Agenda
Village of Arlington Heights
Design Commission
Virtual Meeting

Item: DC#20-072 - 300 E Haven St - SF/Teardown

Project Name: Ajroja Residence
Project Address: 300 E. Haven St.
Prepared By: Steve Hautzinger

NEW RESIDENCE FOR MR. AJROJA

WEST ELEVATION

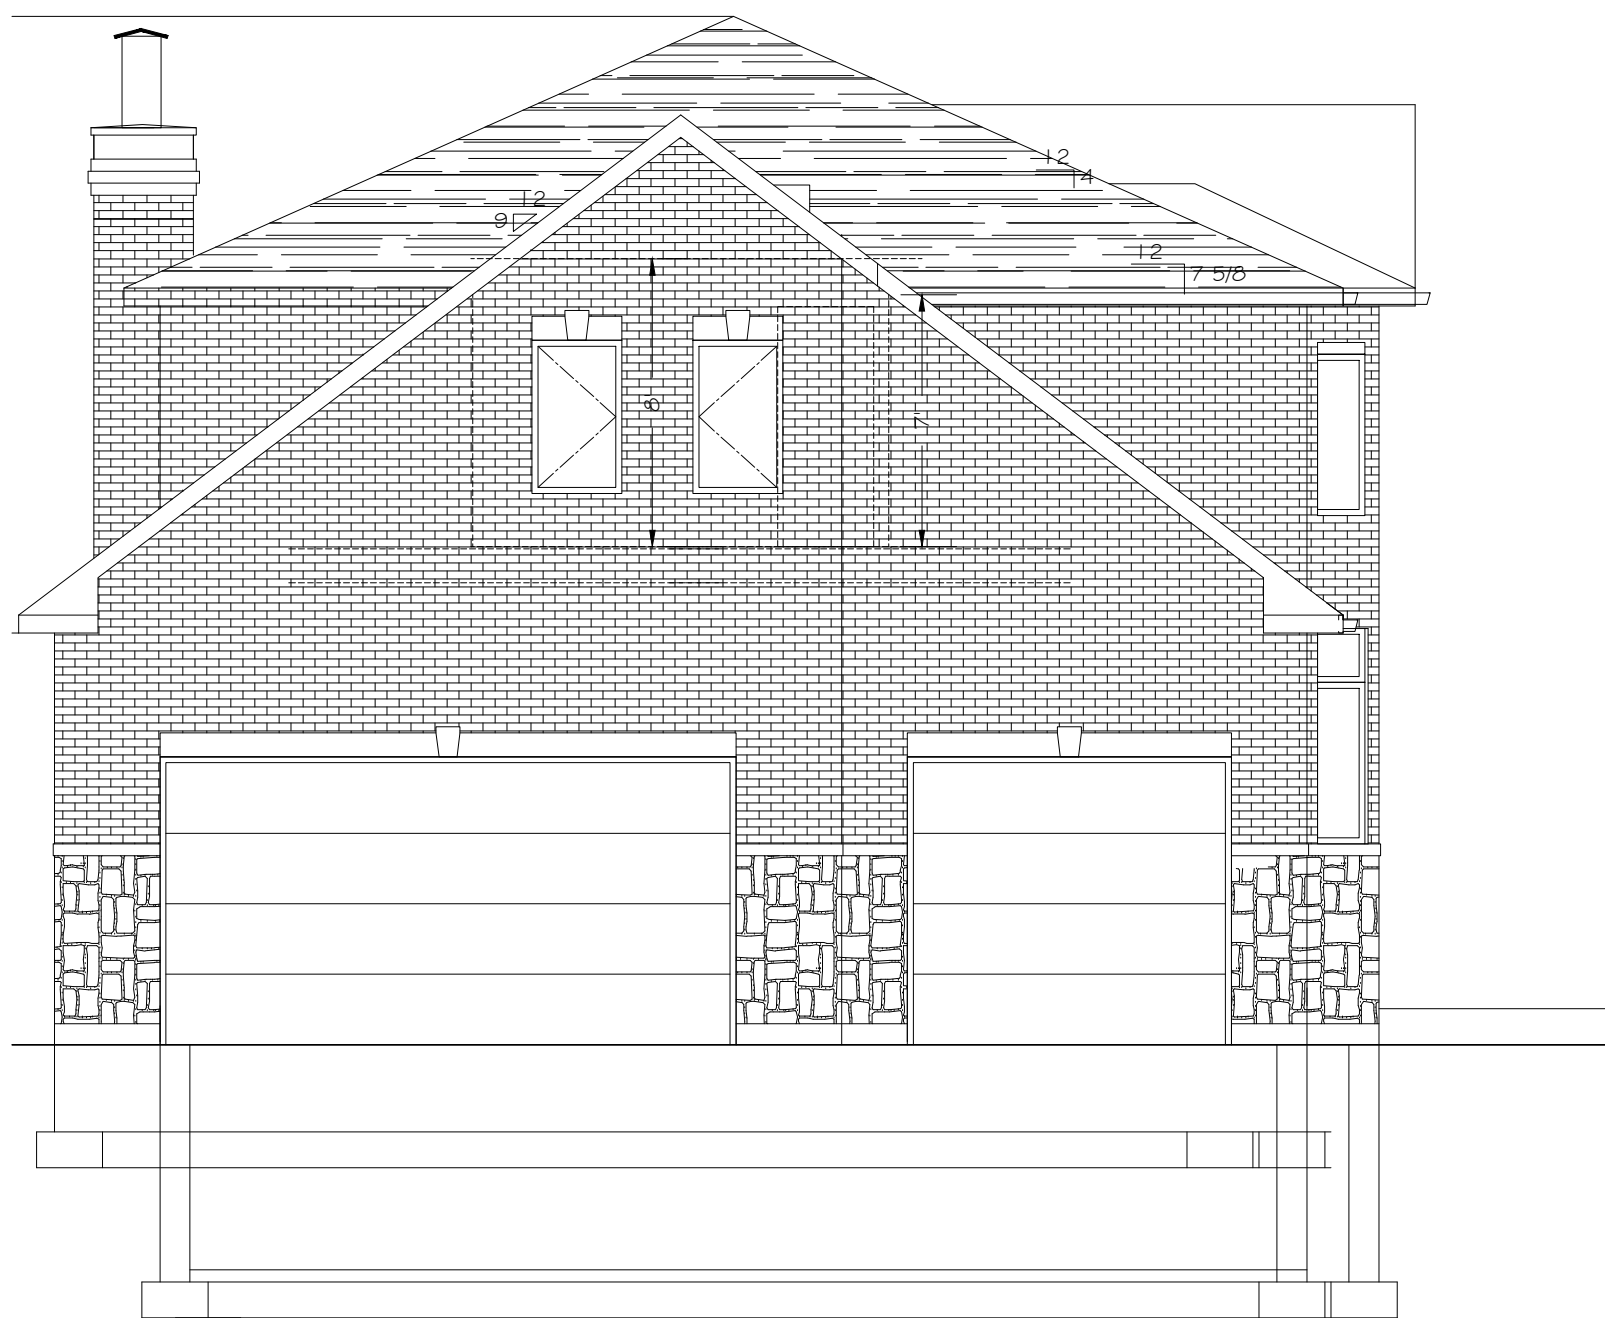
The only comment on the design is that the jog in the face of the garage wall has an odd massing, which is emphasized by the stone quoin detailing at the jog. It is recommended to omit the stone quoins in the middle of the west garage wall.

1. Omit the stone quoins in the middle of the west garage wall.
2. This review deals with architectural design only and should not be construed to be an approval of, or to have any other impact on, any other zoning and/or land use issues or decisions that stem from zoning, building, signage or any other reviews. In addition to the normal technical review, permit drawings will be reviewed for consistency with the Design Commission and any other Commission or Board approval conditions. It is the architect/homeowner/builder's responsibility to comply with the Design Commission approval and ensure that building permit plans comply with all zoning code, building permit and signage requirements.
3. Compliance with all applicable Federal, State, and Village codes, regulations and policies.
